HOUSE CONNECTION NEG6262

SEWAGE DISPOSAL SYSTEM

HOWARD COUNTY HEALTH DEPARTMENT

REPAIR - PURPOSE - TO EXAMINE AND UPGRADE EXISTING WELL AND SEPTIC SYSTEM IN ADVANCE OF PROPOSAL TO REMODEL VACANT HOUSE. Plumbing seen at outside of home wall. Call for inspection when ground is opened so sanitarian can recommend repair - 08/02/94

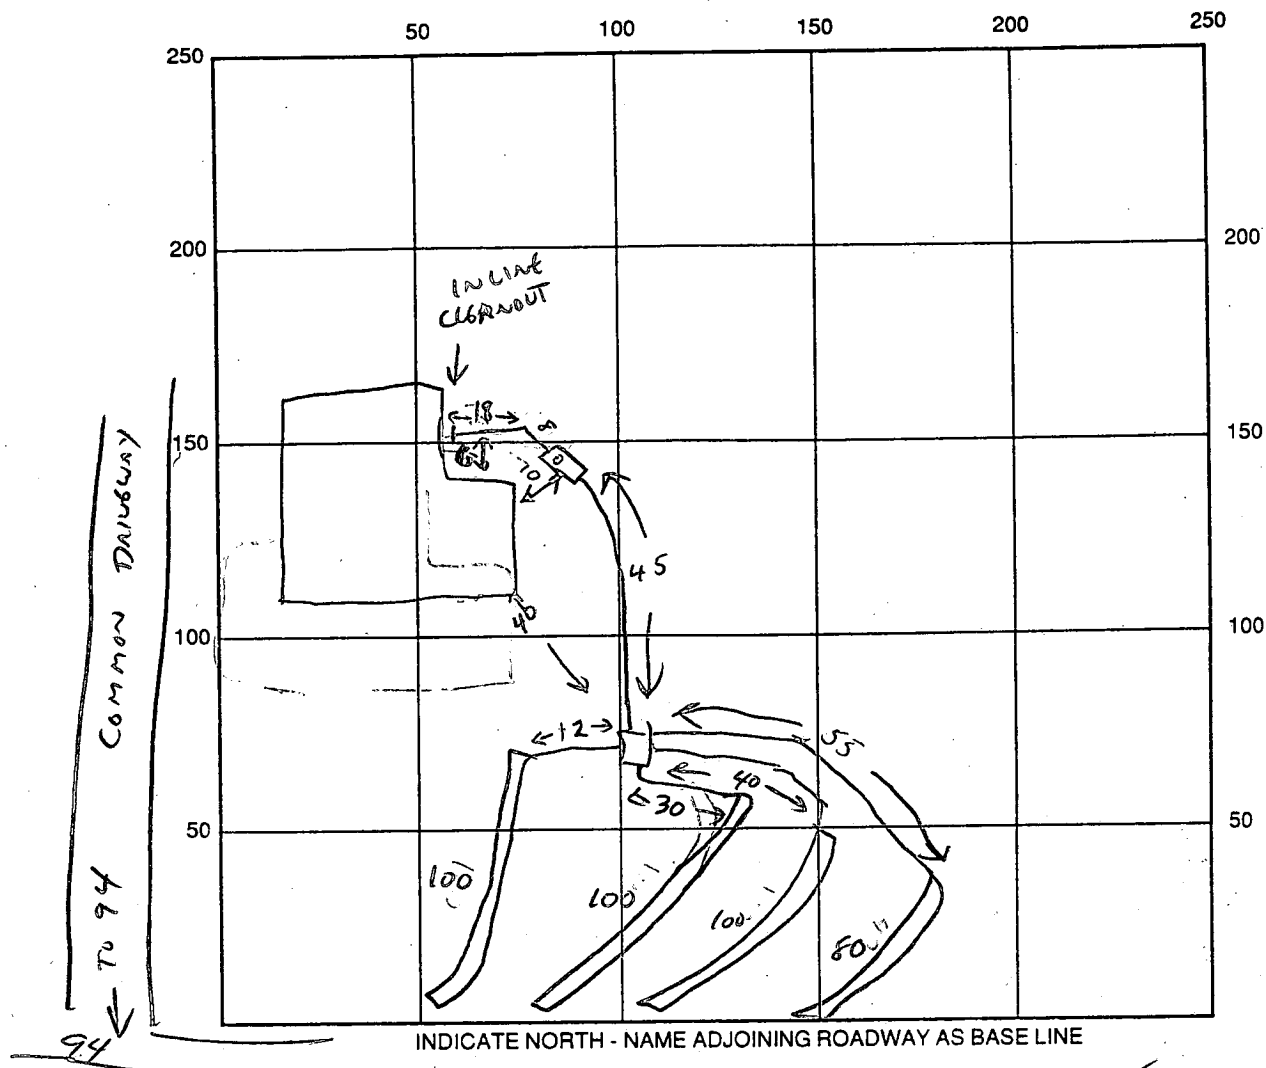
REMARKS: OLDEN HOUSE UNDER RENOVATION - ORIGINAL SEPTIC NOT LOCATED,

- TANK ACCESSIBLE, IT INSTALLED 12" B.G. - OWNER REQUESTS NO CLEANOUT - WILL BE HOUSE PASTURE AREA.

- SEPTIC AREA FLAT - TRENCHES "WANDER" TO AVOID TREES.

- SCHEDULE 40 PIPE HOUSE TO TANK, FLEXIBLE CONNECTED AFTER TANK (LARGE HOLES PIPE).

* NEEDS HOUSE CONNECTION

* WATER SUPPLY UNCERTAIN AT THIS TIME. DILLED WELL & SPRING PREVIOUSLY UTILIZED 8/17/94

12/10/99 No house connection observed - File indexed but syst. not approved.

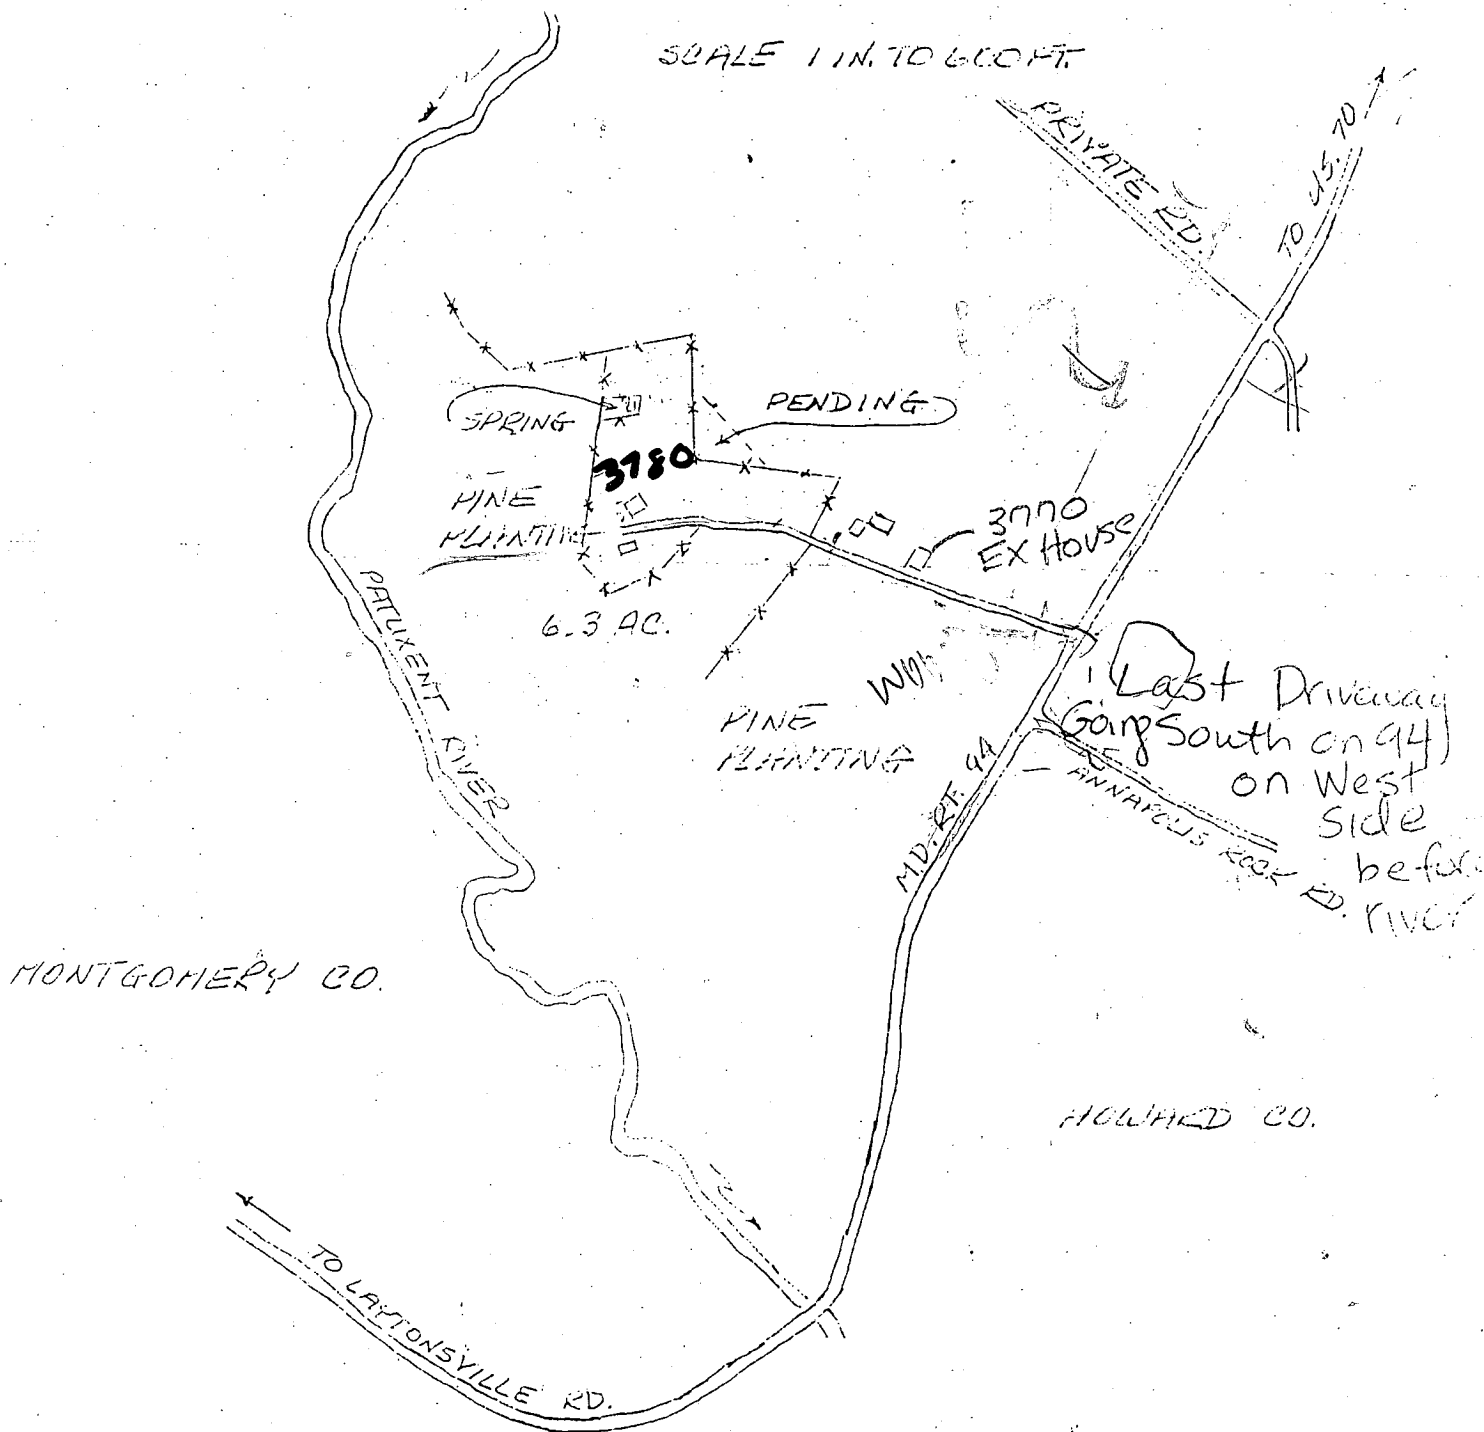
REMARKS 8/3/94 → System +/or due to existing home 2-Repaired or 1 System

TYPE OF SOIL Below clay - Loam + some weathered shale

[Shallow only - dug to 6' only] 4 Bedroom 3 1/2 37 3 of him

TRENCH DESIGN DATA: AVERAGE PERCOLATION TIME 25m TRENCH WIDTH 3

INLET DEPTH 4 1/2 MAXIMUM BOTTOM DEPTH 6 1/2 SQ. FT./BEDROOM 280
